United States Nuclear Regulatory Commission  
Document Control Desk  
Washington, D. C. 20555-0001Subject: Response to Request for Additional Information Regarding Proposed  
Alternative to American Society of Mechanical Engineers Code Section XI  
Repair Requirements (TAC No. MD4452)

**RESPONSE TO REQUEST FOR ADDITIONAL INFORMATION  
 DAVIS-BESSE NUCLEAR POWER STATION (DBNPS)  
 10 CFR 50.55a REQUEST REGARDING INSTALLATION OF  
 STRUCTURAL WELD OVERLAYS (TAC NO. MD4452)**

**FIRSTENERGY NUCLEAR OPERATING COMPANY  
DAVIS-BESSE NUCLEAR POWER STATION  
THIRD 10-YEAR INTERVAL REQUEST RR-A30, REVISION 2**

**Materials**

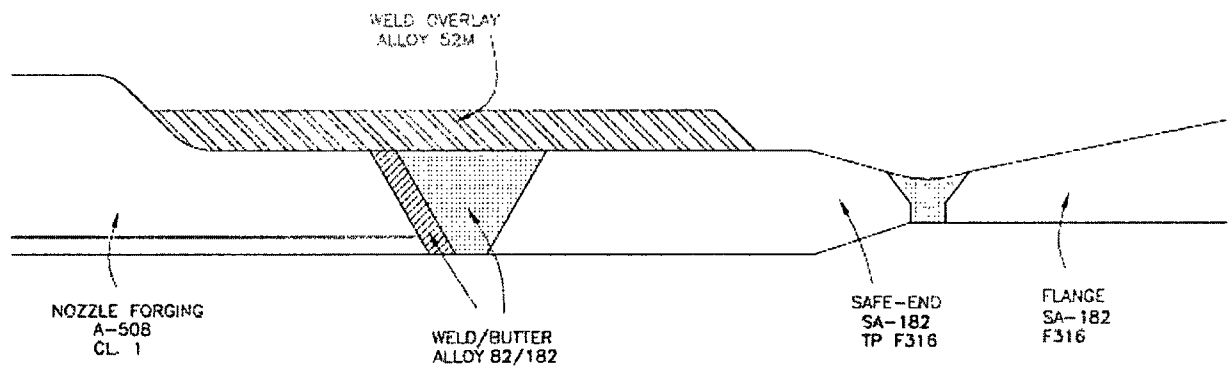
- (a) For each candidate weld, identify the material specification and P number of each affected component (e.g., nozzles, safe ends, flanges, piping, and hot leg branch connections).
- (b) Weld RC-PZR-FW22 is the similar metal weld joining the 4-inch pressurizer relief nozzle safe end and the valve flange. This weld is associated with weld RC-PZR-WP-91-W/X which joins the 3-inch W/X axis pressurizer relief nozzle and the safe end. Explain why these two welds have two different diameters even though they seem to belong to the same relief valve piping.

Location	Nozzle	Safe End	Pipe/Fitting
3" Pressurizer Safety Nozzles – Welds RC-PZR-WP-91-W/X RC-PZR-WP-91-Y/Z	A-508 CL 1 (P-No. 1 Group 2)	SA-182 TP F316 (P-No. 8 Group 1)	SA-182 TP F316 Flange (P-No. 8 Group 1)
10" Hot Leg Surge Nozzle Weld – RC-MK-A-82-FW54	A-105 GR 2 (P-No. 1 Group 2)	N/A	A-376 TP 316 Pipe (P-No. 8 Group 1)
2½" Pressurizer Relief Valve Nozzle – Welds RC-PZR-WP-91-Z/W RC-30-CCA-8-1-FW10	A-508 CL 1 (P-No. 1 Group 2)	SA-182 TP F316 (P-No. 8 Group 1)	SA-376 TP 316 Pipe (P-No. 8 Group 1)
12" Hot Leg Decay Heat Nozzle Weld – DH-33A-CCA-4-1-FW1	A-105 GR 2 (P-No. 1 Group 2)	N/A	SA-403 WP 316 Elbow (P-No. 8 Group 1)
10" Pressurizer Surge Nozzle – Weld RC-PZR-WP-23	A-508 CL 1 (P-No. 1 Group 2)	A-336 CL F8M (P-No. 8 Group 1)	N/A
4" Pressurizer Spray – Welds RC-PZR-WP-102 RC-MK-A-90-FW56	A-508 CL 1 (P-No. 1 Group 2)	SB-166 (P-No. 43)	A-376 TP 316 Pipe (P-No. 8 Group 1)

Pressurizer 3" Safety/Relief Nozzle Weld Overlay

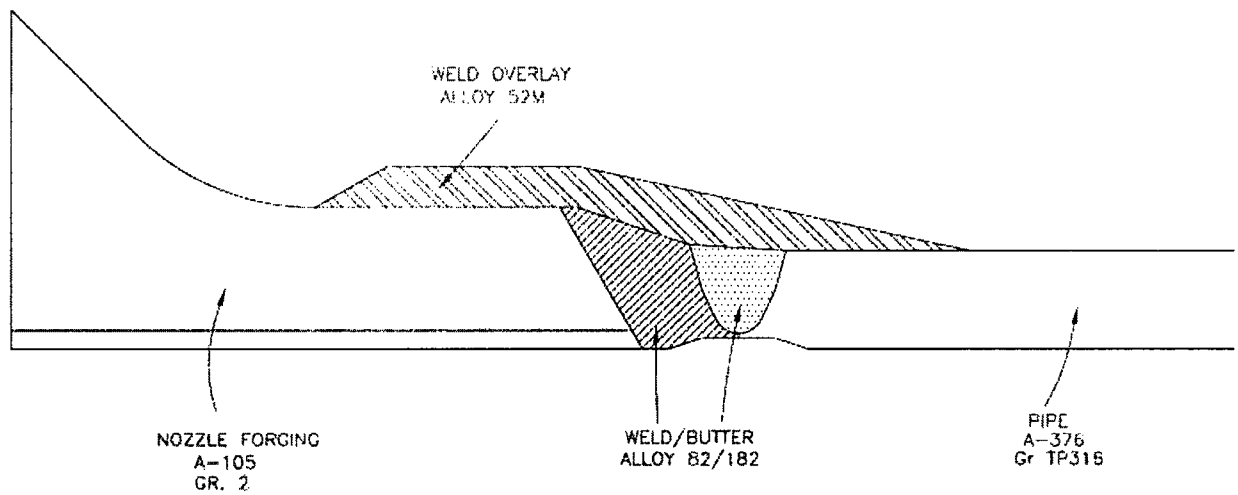
- (c) Provide drawings or sketches of the weld configuration of each of the components listed in Section 1 of request RR-A30.

(c) Sketches are as follows:
